## #274 ROOF DRAIN DISCREPANCY

RFI Title: Roof Drains - North side Locations

**AWSOM**  
 Bentonville, AR

THIS PAGE IS BEST VIEWED IN COLOR  
**A103S**

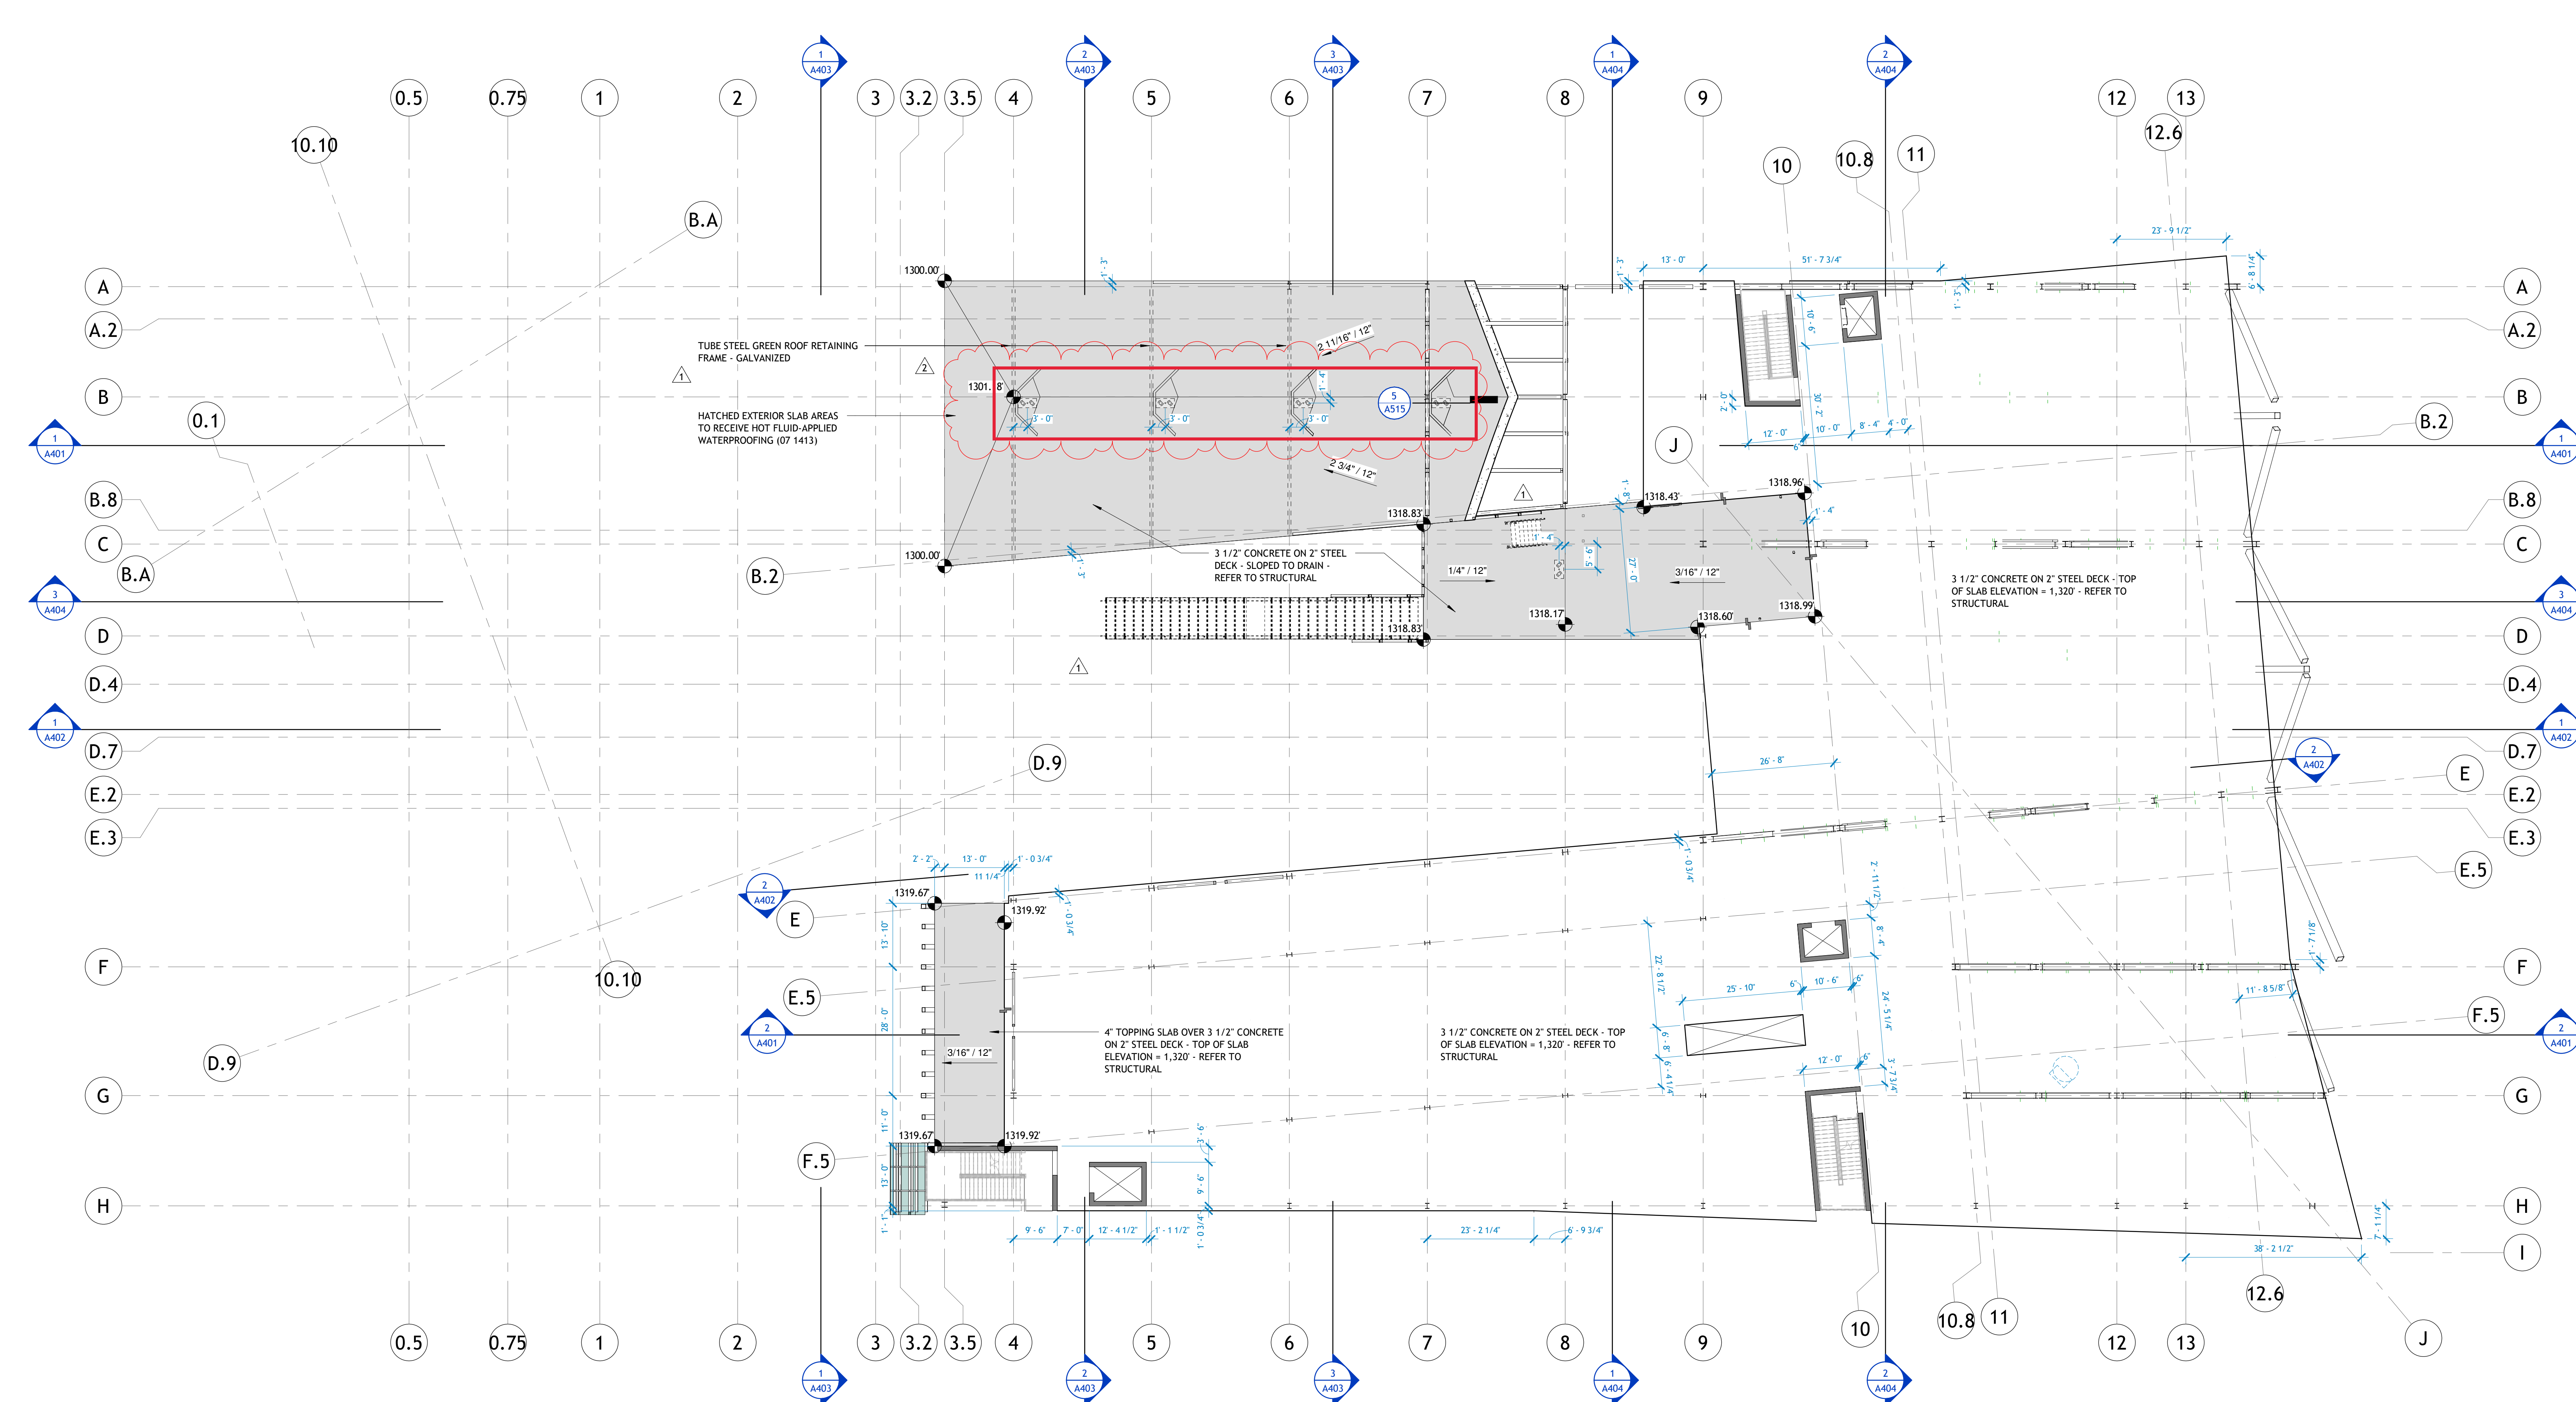
-The architectural and BIM model have the drains drawn along grid lines 4-7. (see attached A103S) There is no piping at Grid line 4 to support the roof drains drawn in the architectural prints.

- The architectural and BIM model have the drawn along grid lines 4-7. (see attached A103S) There is no piping at Grid line 4 to support the roof drains drawn in the architectural prints.
- The Plumbing plans have them drawn along grid lines 5-8. (see attached P102A, P103A, & P105A)

Anne Worley (Polk Stanley Wilcox Architects): The design team will issue a PR which will include adding piping for drain at grid 4 and revised architectural roof plan showing added drain and access manhole on grid 8. Piping for drains at grid 4 will tie in with grid 5 drain piping.

1 PLUMBING WASTE & VENT - LEVEL 2 PLAN - AREA A  
1/8" = 1'-0"

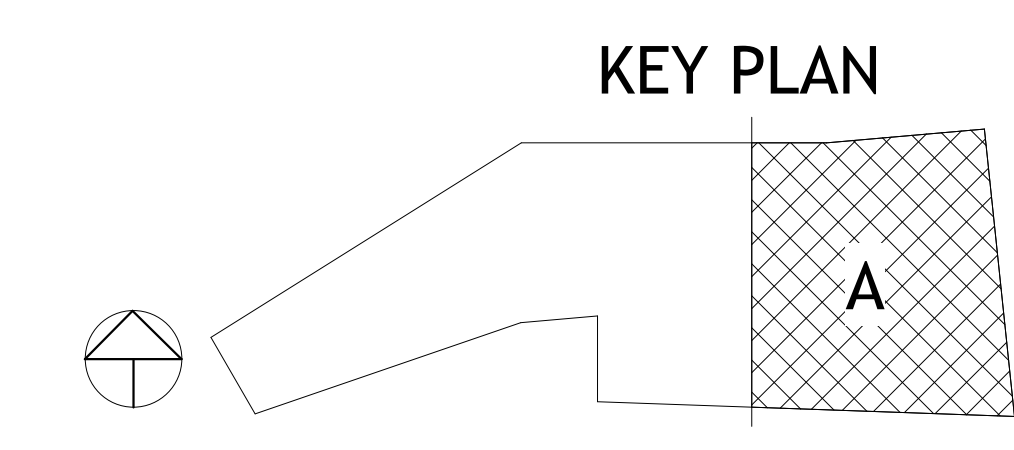
-The plumbing plans have them drawn along grid lines 5-8. (see attached P102A, P103A, and P105A)

The nearest roof drain to grid line 4B is at gridline 5B. CSUSA is unsure if there is enough room to run a pipe to grid line 4. There are no overflows close enough to grid line 4. These may need to run through the floor to level 0 or moved in the BIM/Architectural sheets to reflect the plumbing design.
